37 QUINCY STREET, CHEVY CHASE

## HISTORIC PRESERVATION COMMISSION

SUBJECT: Historic Area Work Permit #624132, demolition of rear addition and construction of 2 story addition, screen porch and deck, and addition of three dormers on front facade

**MONTGOMERY COUNTY HISTORIC PRESERVATION COMMISSION**  
**STAFF REPORT**

PROPOSED FRONT  
ELEVATION

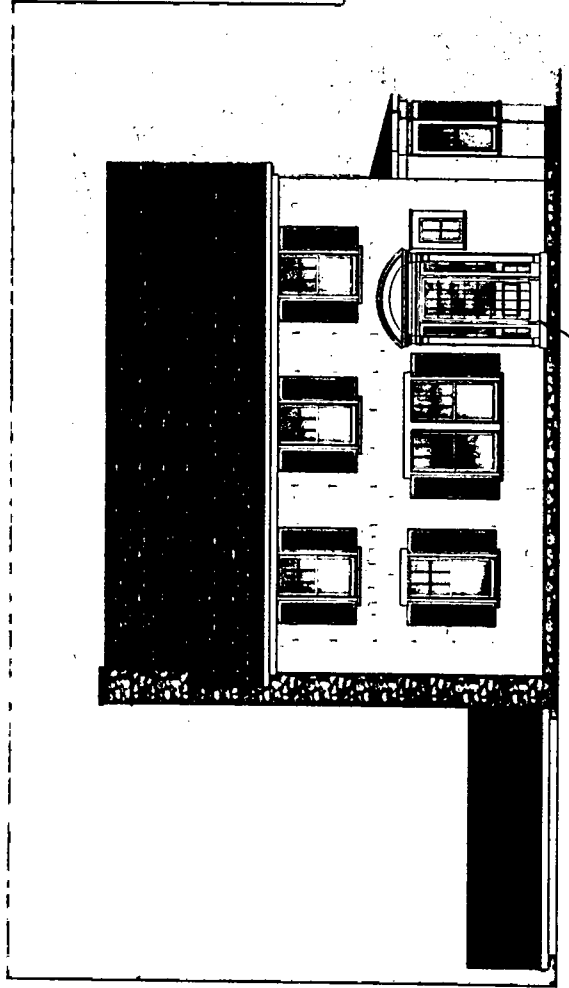
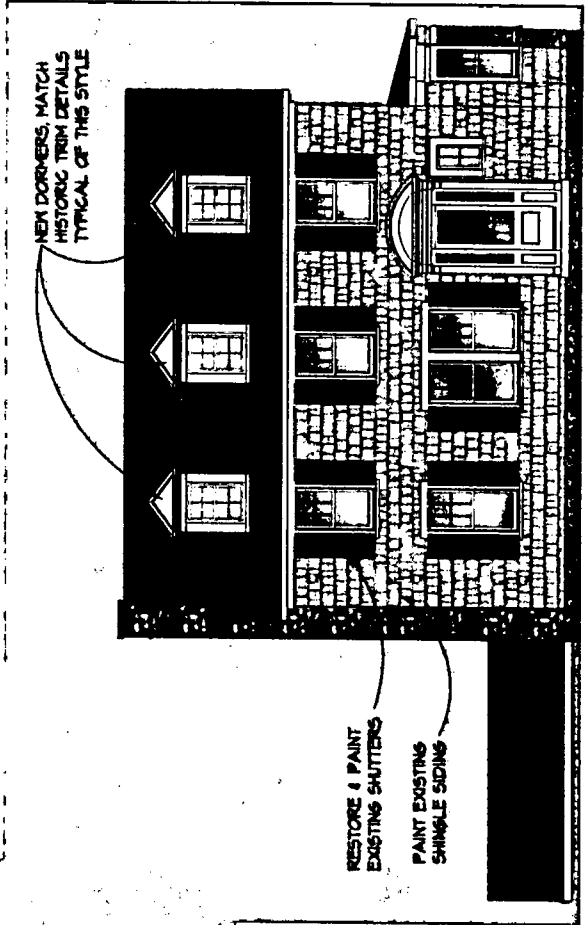
The front entry portico is a character defining feature, and is included in the 1927 Sandborn map. Over time, the portico was altered by adding multi-pane side glass panels to the sides of the portico, a multi-pane divided light door, and sidelight panels. Based on the way the top glass enclosure meets the portico beam and how it is disengaged from the rest of the porch structure, the applicant does not believe these glass enclosures are original to this architectural feature. The applicant is proposing to remove all three sides of the glass enclosure so that it is a typical portico with the pediment and entablature sitting on the existing freestanding columns. Staff supports the removal of the panels and the restoration of this feature.

DEMO EXS. GLASS ENCLOSURE  
RESTORE EXISTING PORTICO

NEW DORMERS MATCH  
HISTORIC TRIM DETAILS  
TYPICAL OF THIS STYLE

1. The elevations read that the application includes the demolition of the existing glass enclosure and restore existing portico. Can you please clarify what this means - does this mean that the glass side panels will be removed or that you simply want to take out the glass? We would like to remove all three side of the glass enclosure, the two side glass panels and the front door/sidelite panel, so that it is a typical portico with the pediment and entablature sitting on the existing freestanding columns. Based on the awkward way in which the top of the glass enclosure meets the portico beam and how it is disengaged from the rest of the porch structure; I do not believe it to be original to the house.

1 EXISTING RIGHT SIDE ELEVATION  
SCALE: 1/4" = 1'-0"

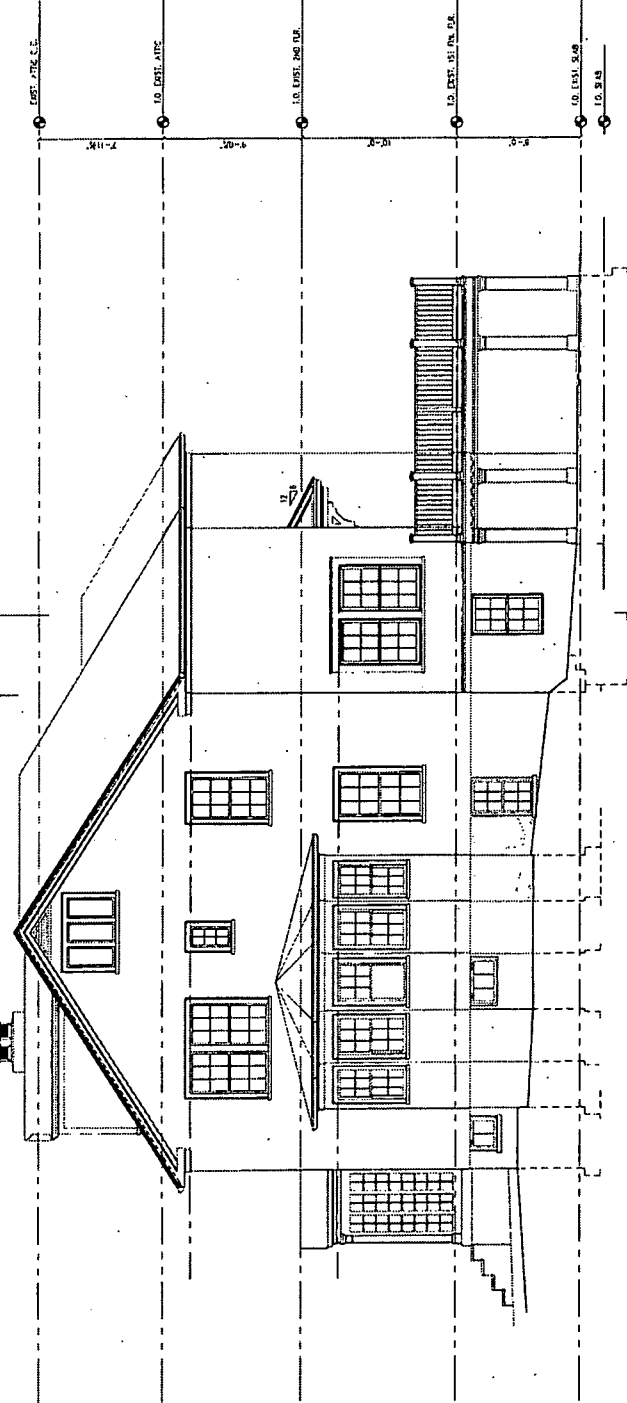
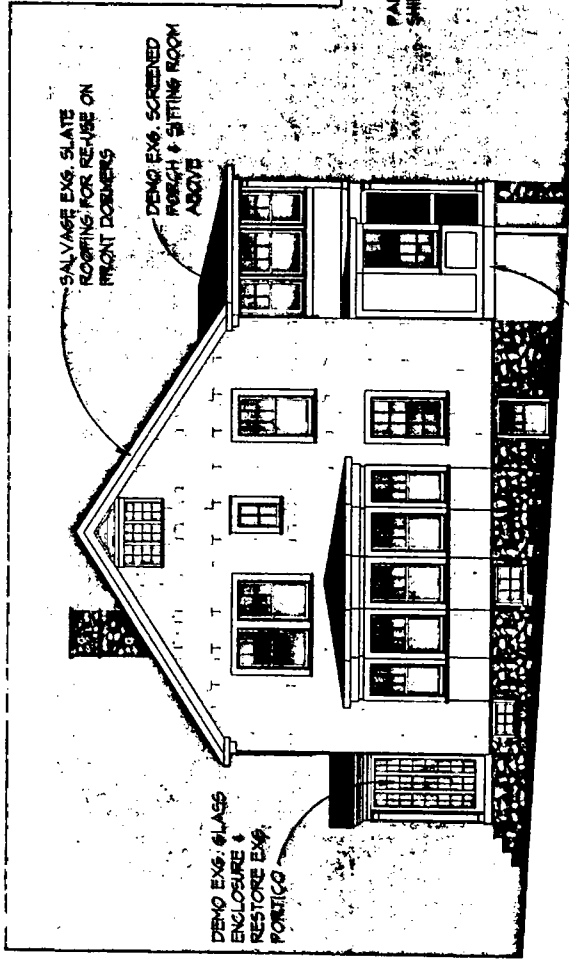
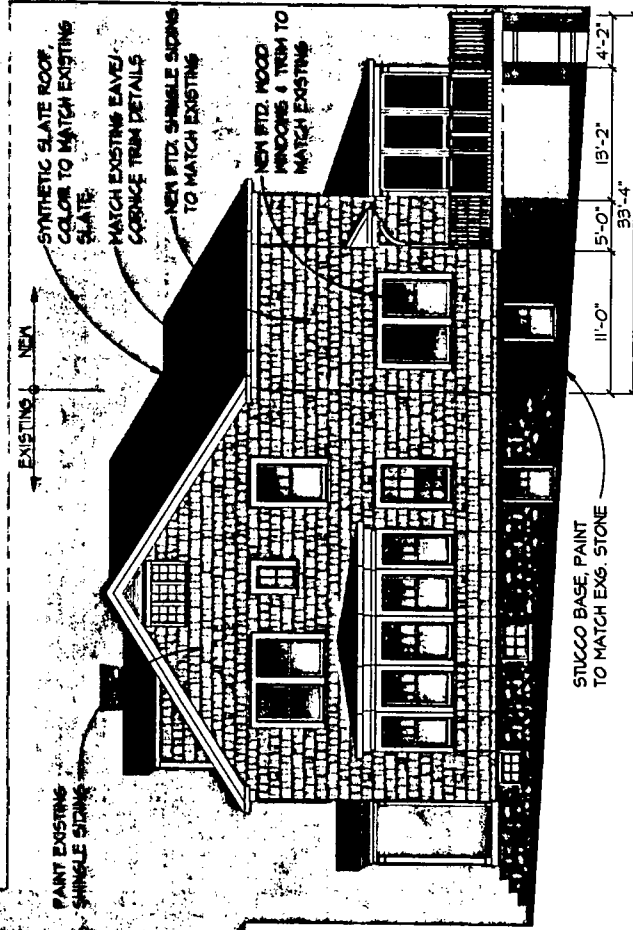
- Remove the screened porch (16'10" x 12'6") from the addition.
- Revise the size of the new deck from 13' x 18'8" to 17' x 18'8". The revised deck has been reoriented and now projects 5' out past the right side of the historic block. The applicant has held it within the line of the existing bay window, which extends approximately an additional 2', so it is screened from the streetscape. There is also mature vegetation and trees on this part of the lot to further screen the addition.

**STAFF RECOMMENDATION:** Staff recommends that the Commission approve the revised proposal described above finding it as being consistent with Chapter 24A-8(b)(1) & (2):

PROPOSED REAR ELEVATION

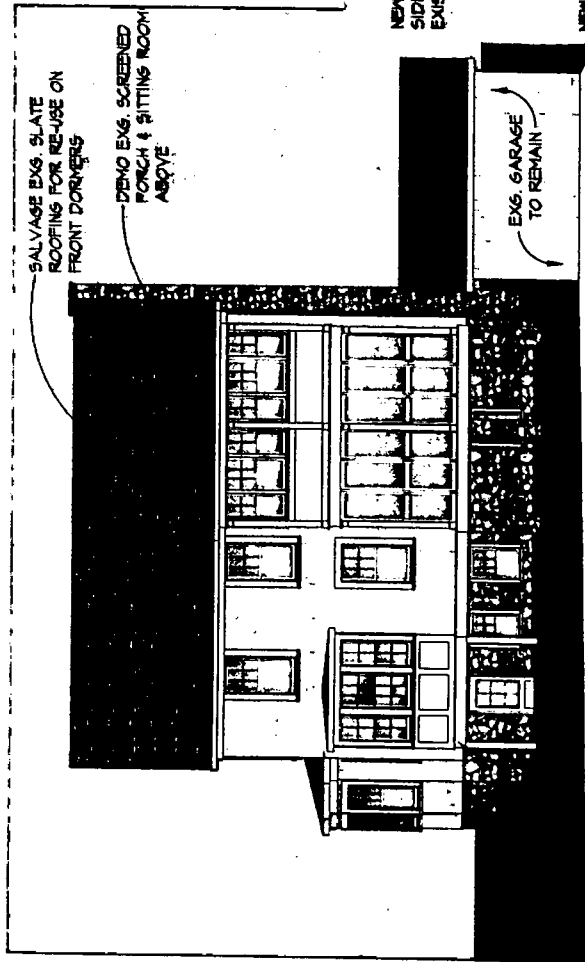
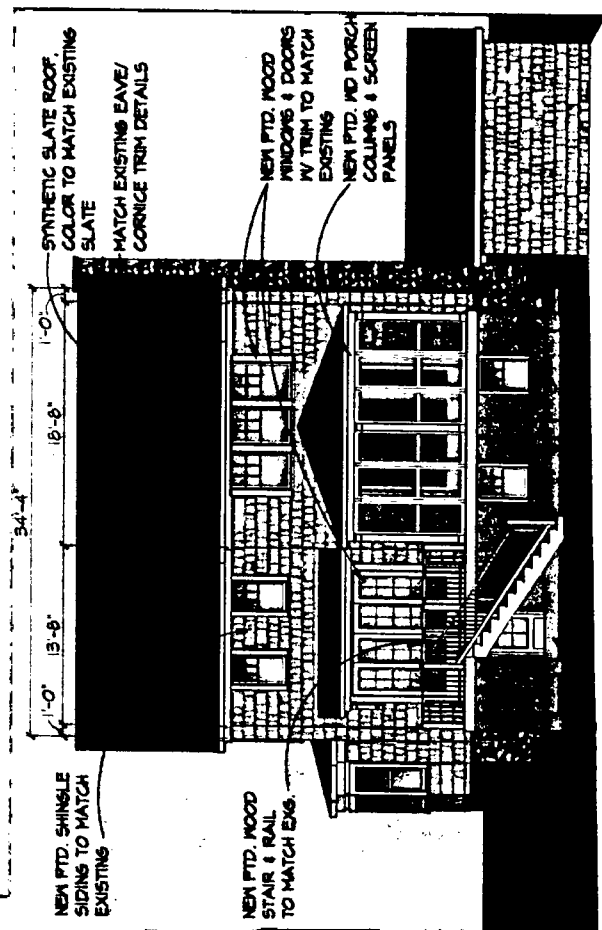
As noted in the Applicable Guidelines, most changes to the rear of the properties should be approved as a matter of course. At the rear, the applicant is proposing to remove the existing 2-story feature on the right rear and a one-story feature on the left rear. In their place, the applicant is proposing a two-story addition and basement. The addition will include a rec room (16'8" x 15'), a mud room (13'9" x 10') on the basement level, a family room (17'8" x 15'6") and a breakfast room (13'8" x 11') on the first floor, and a master bedroom (17'8" x 15'6") and suite (13'8" x 11") on the second floor. The application includes a screened porch (16'10" x 12'6") and a deck (13' x 18'8") on the first floor, with steps off the deck leading to the basement and areaway below. The addition runs the full expanse of the width of the house but is set in one foot on both sides. The non-contributing freestanding garage and existing tree are to

The 1927 Sandborn map indicates the two-story feature on the right rear of the house is original, but that it may have been an open porch and thus altered over time. Per the applicant, based on the change in materials and window style, the first floor porch was later screened in and the second floor porch was enclosed to create a sleeping porch. While the Sandborn map indicates there was a two-story feature on the left rear side as well, it is staff's understanding that the existing one-story addition is not an original feature. Unlike the right rear addition, it is supported by wood posts instead of stone piers.

2. Can you speak about the 2 story and one story features on the rear of the house that will be demolished for the new addition. Do you have any evidence that these are not original features to the house? Is there any indication

whether they have been altered over time? Did you consider incorporating these features in the new addition? It looks like the original house had a two story porch on the rear. Based on the change in materials and window style, the First Floor Porch was later screened-in and the Second Floor Porch enclosed to create a Sleeping Porch. Recently, the Second Floor has been further remodeled so that the Sleeping Porch is completely enclosed and part of the Master Bedroom. Based on the different materials and construction methods used, the Breakfast Room is not an original structure. Unlike the Porches, it is supported by p/t wood posts instead of stone piers. There is a change in deck materials between the Screened Porch and the connector to the Breakfast room, and the Breakfast Room and Sleeping Porch have different details, signifying that they were renovated & enclosed at different times.

It was our understanding that, in general, you are able to selectively demolish and add on to the rear of the residence. Both structures are entirely on the rear of the house and not visible from the street. Both the Breakfast Room and the enclosed Screened Porch do not have insulated floors and have no heating or cooling. I very much doubt there is insulation in the walls based on the thickness and apparent construction methods. Given our clients program and intended use for the space created by the addition, we would be unable to execute it by incorporating the existing structures. In addition the construction quality of the existing structures is such that we would probably have to demolish and rebuild them to do so. Given all of these factor, we thought it best to remove these structures and construct an addition that would not only improve the usability and value of the home, but also be more in line with the aesthetic of the original house and beneficial to the overall character of the neighborhood.
